Proposed Section 4.55 (2) Modification  
DA/2021/1460

Modification of Approved Subdivision – Stage 0 and 8 to 15

799 New England Highway and 70 Christopher Road, Lochinvar

November 2024

Figure 4: Extract of Approved North Basin under DA/2021/1460 (Source: BRS, 2023)

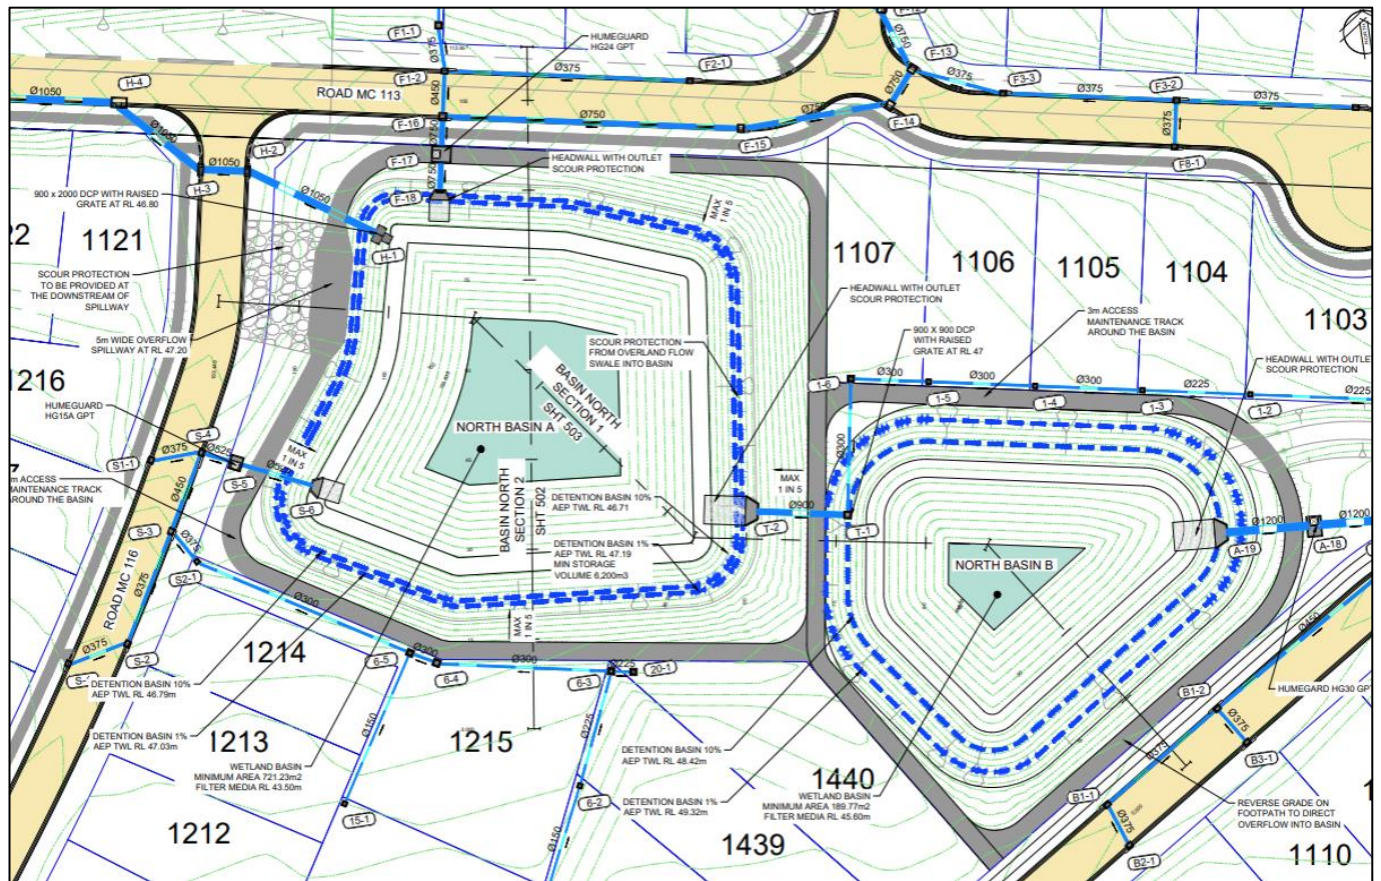
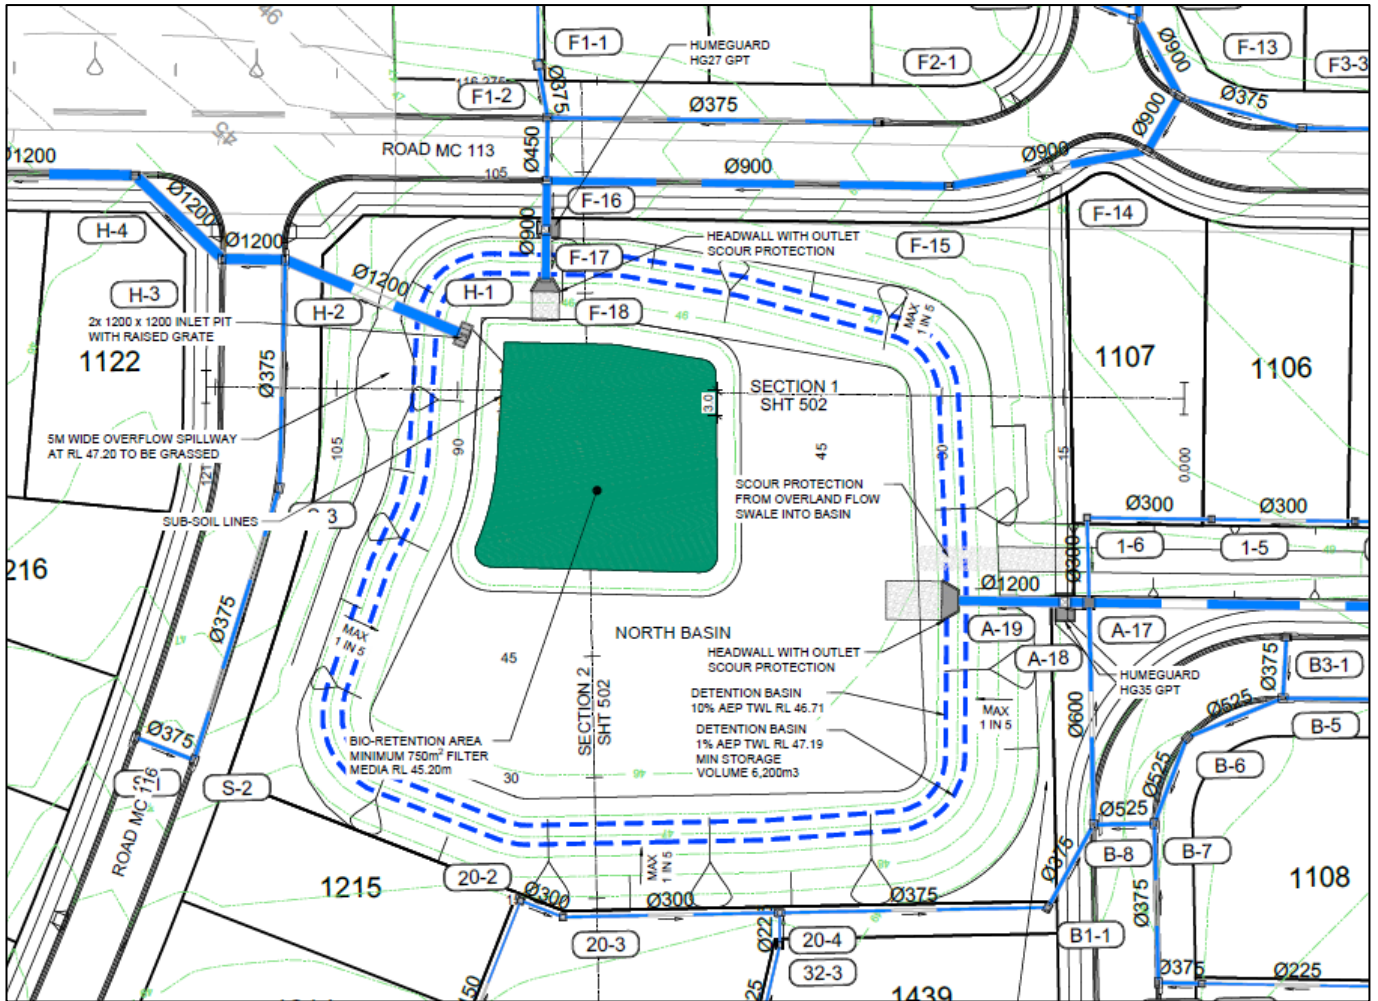
The detention basin within Stage 11A, known as the north basin, is proposed to be segmented into two basins (upper and lower) and increased in size and volume. The modification also seeks to amend the basin type from a dry basin to wet basin. This amendment will require modification to the lot layout within stages 11A, 12 and 14, as discussed in Section 3.2 below. An extract of the modified detention basin is provided in **Figure 3**. **Figure 4** provides an extract of the stamped approved plans for comparative purposes. Refer to Appendix A for further details.

Figure 5: Extract of Proposed South Basin (Source, BRS: 2024)

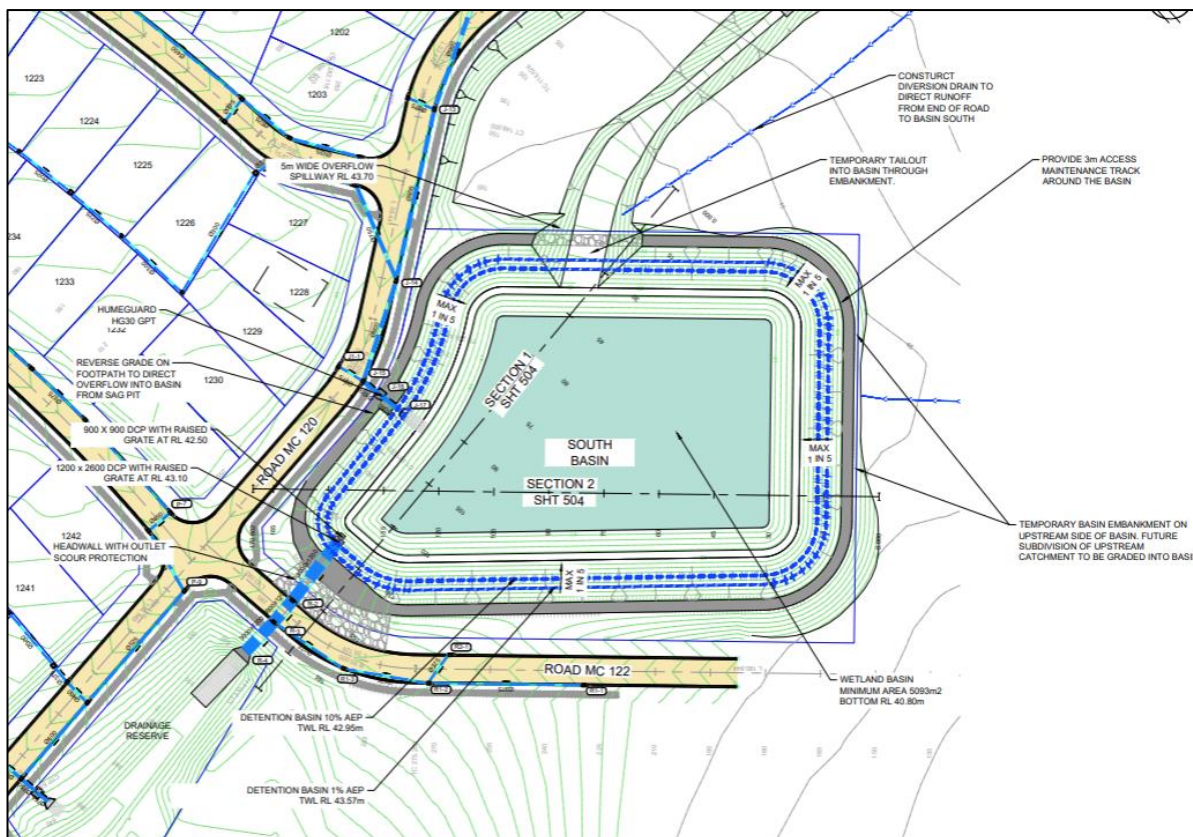
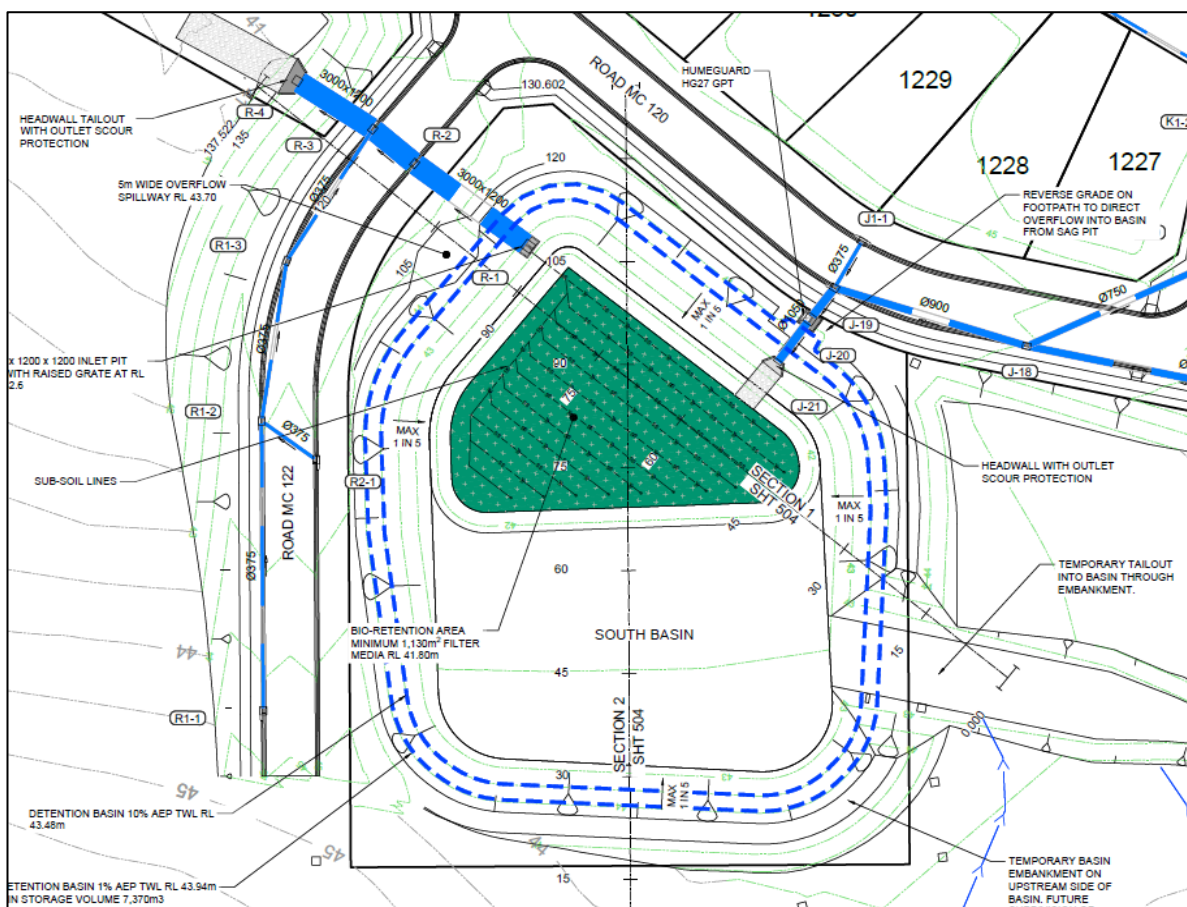
The detention basin within Stage 12, known as the south basin, will be extended in length and increased in size and volume. This detention basin will also be converted to a wet basin from the previously approved dry basin. An extract of the modified detention basin is provided in **Figure 5**. **Figure 6** provides an extract of the stamped approved plans for comparative purposes. Refer to Appendix A for further details.

Figure 7: Extract of Proposed Lot Layout Modifications (Source, BRS: 2024)

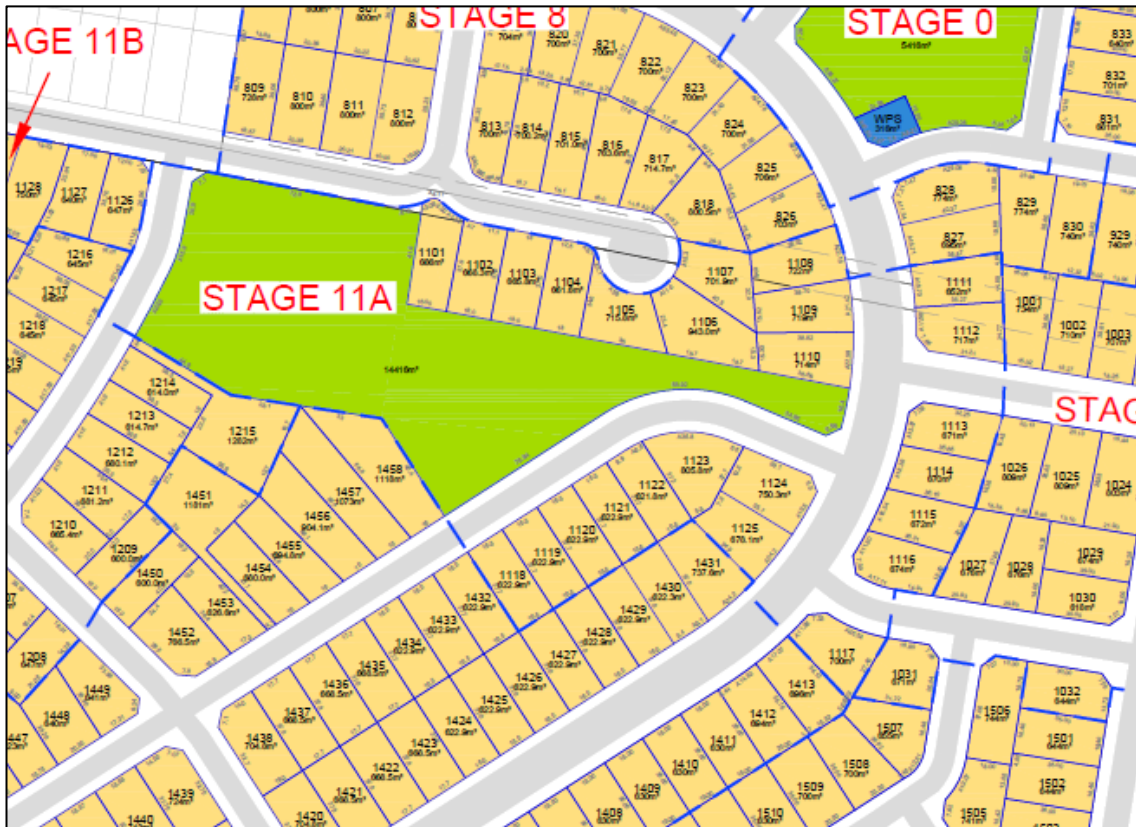
The modification proposes to amend the lot layout of parts of Stage 11A, 12 and 14 to accommodate the proposed changes to the north basin, as discussed in Section 3.1 above. The modification will require a restructuring to the proposed lots surrounding the basin, resulting in the following –

- Modification to a total of 27 lots.
- Loss of a total of one (1) lot.
- Removal of one road (Road MC114) and proposed design modification of another (Road MC 118).
- Adjustment to retaining wall locations.
- Adjustment to drainage to facilitate new road and lot arrangement.

An extract of the proposed lot layout incorporating modifications is provided in **Figure 7**. **Figure 8** provides an extract of the stamped approved plans for comparative purposes. Refer to Appendix A for further details.

Figure 9 - Extract of Proposed Staging Modifications (Source, BRS: 2024)

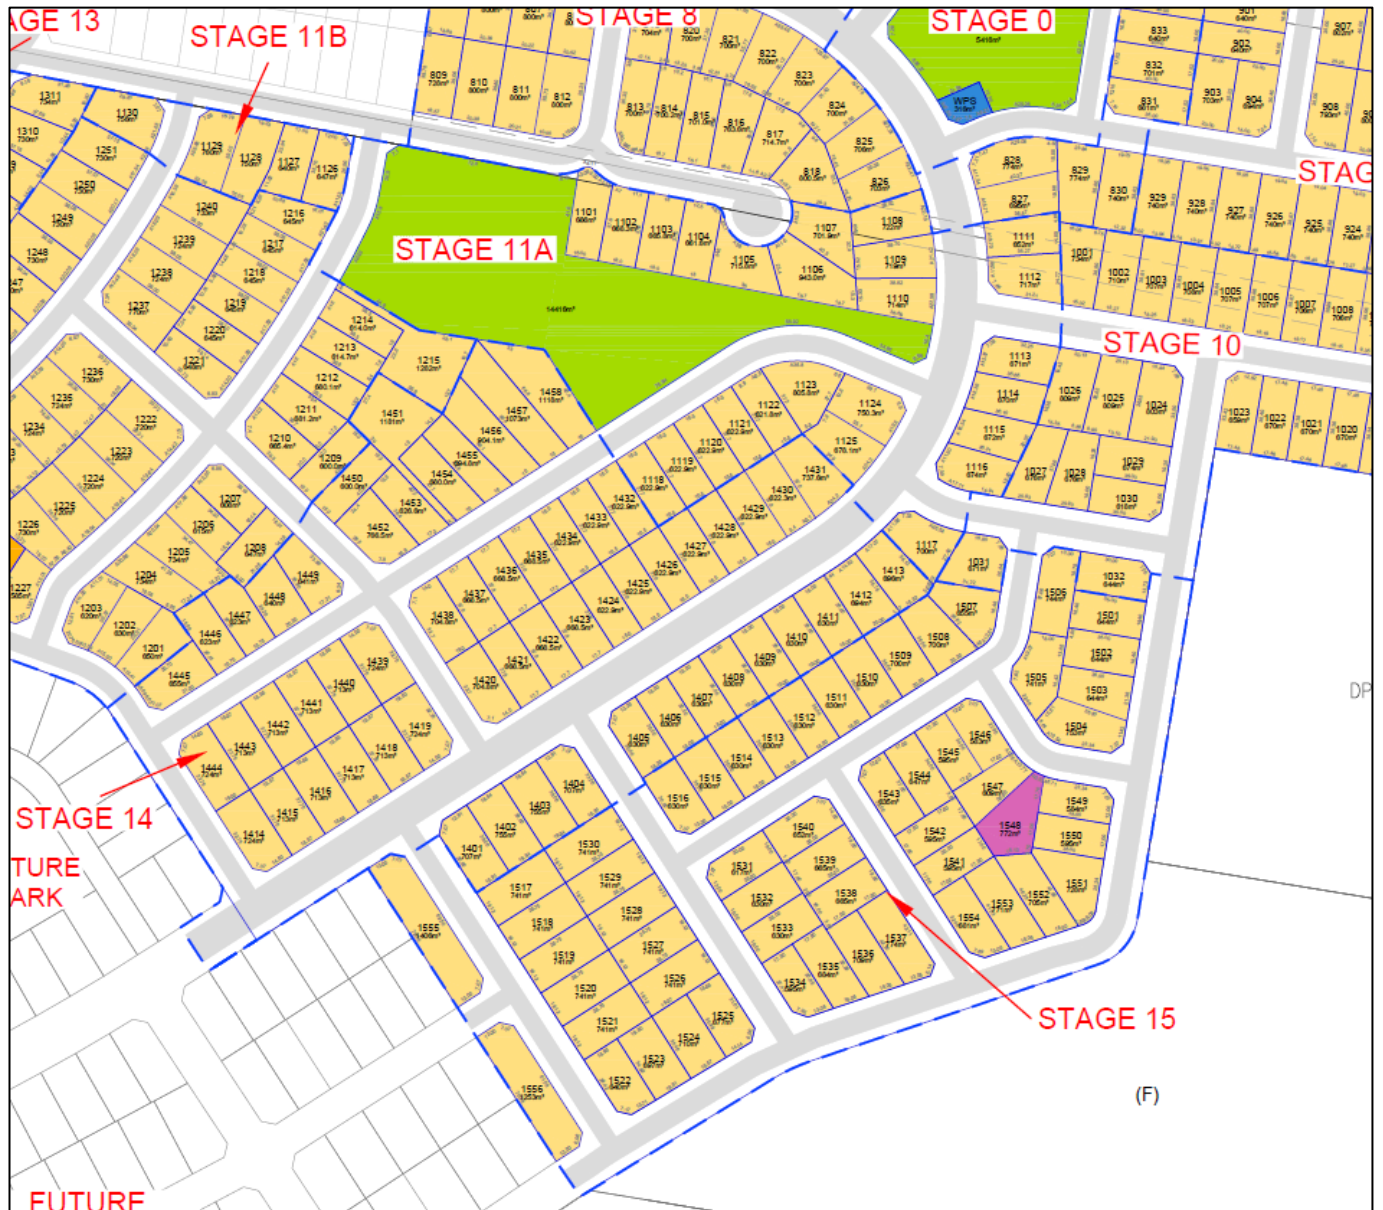
The modification proposes to alter the stage boundaries of stages 10, 11A, 14 and 15 and amend the delivery of a number of lots within these stages to alternate stages to reflect the proposed boundary adjustments. The proposal incorporates the following –

- Relocate 8 lots from Stage 10 to Stage 11A (1001, 1002, 1029, 1030, 1031, 1032, 1039, 1040 and 1041)
- Relocate 1 lot from Stage 15 to Stage 11A (1517)
- Relocate 5 lots from Stage 11A to Stage 14
- Relocate 13 lots from Stage 15 to Stage 14 (1518, 1519, 1520, 1521, 1522, 1523, 1524, 1525, 1526, 1527, 1528, 1529 and 1530)

The purpose of the modification is to align with the orderly delivery of the proposed modified Stage 11A. The extension of Stage 11A is proposed to incorporate a portion of Herdsmen Road (MC101) which will provide access to Road MC118 which is required for the delivery of the proposed amended north basin.

An extract of the proposed staging incorporating modifications is provided in **Figure 9**. **Figure 10** provides an extract of the stamped approved plans for comparative purposes. Refer to Appendix A for further details.

Figure 12: Extract of Approved General Arrangement Sheet 103 under DA/2021/1460 (Source: BRS, 2023)

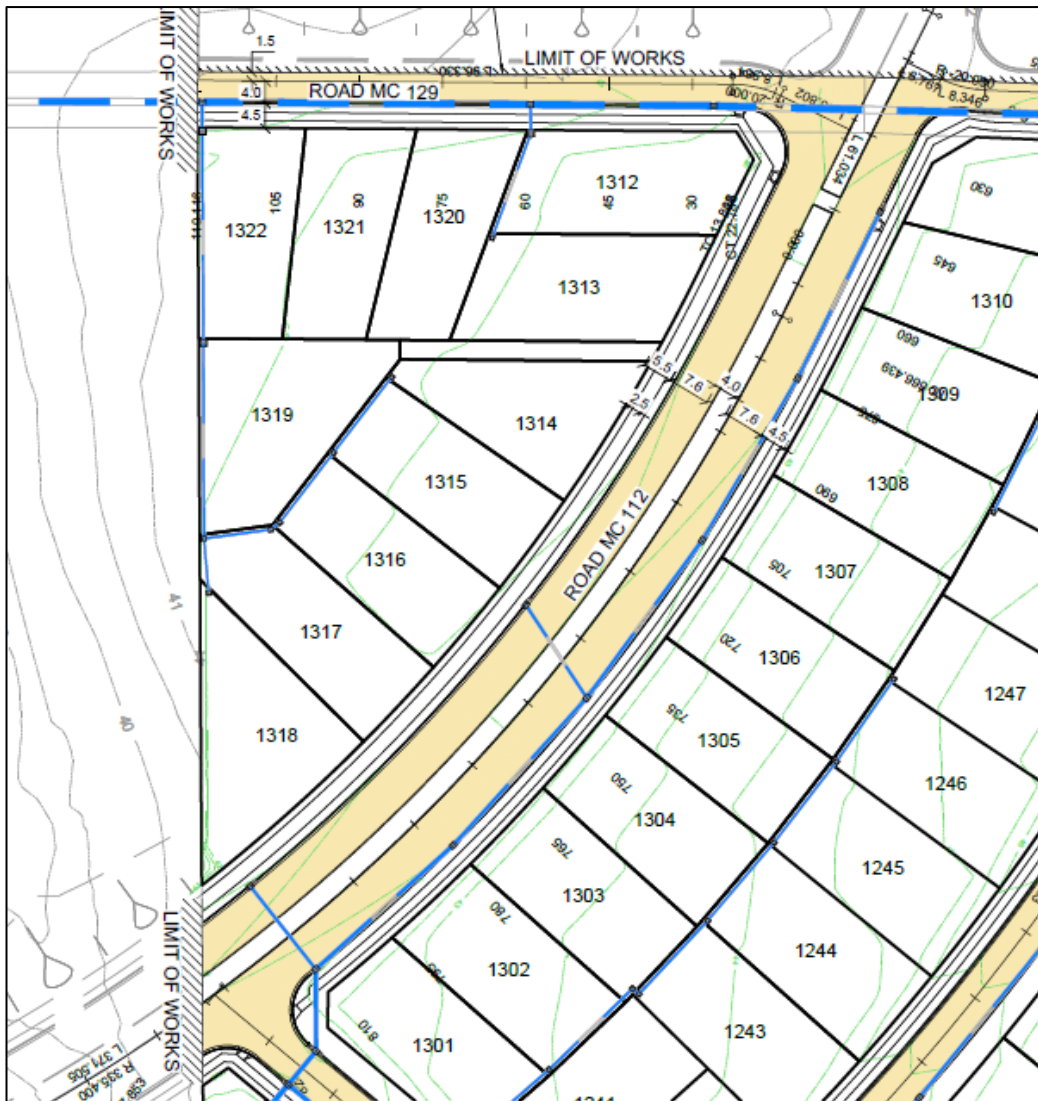
The modification proposes to relocate a portion of road north of Stage 13, to within the site. The purpose of this modification is to align the road with an existing trunk water main. Under the previous approval, the road directly adjoined the site boundary to the north. An existing trunk water main runs through the site affecting proposed lots 1312, 1230, 1321 and 1322. It is understood that the trunk water main and its associated easement is to be located on public land. As such, the proposed modification seeks to relocate the road to capture the water main and easement within public land. This is in line with the adjoining subdivisions which already have SWC approval.

The modification also proposes to shift the location of Springfield Drive (Road MC 112) to allow coordination between adjoining residential development. The southern extent of the road will be shifted slightly in a southern direction to align with the adjoining Lochinvar Downs development to the west.

The proposed modifications to the road network results in minor design changes to the 22 lots within Stage 13, including the size of 19 lots. The configuration of the lots will generally remain the same. An extract of the modified road network and lot layout is provided in **Figure 9**. **Figure 10** provides an extract of the stamped approved plans for comparative purposes. Refer to Appendix A for further details.
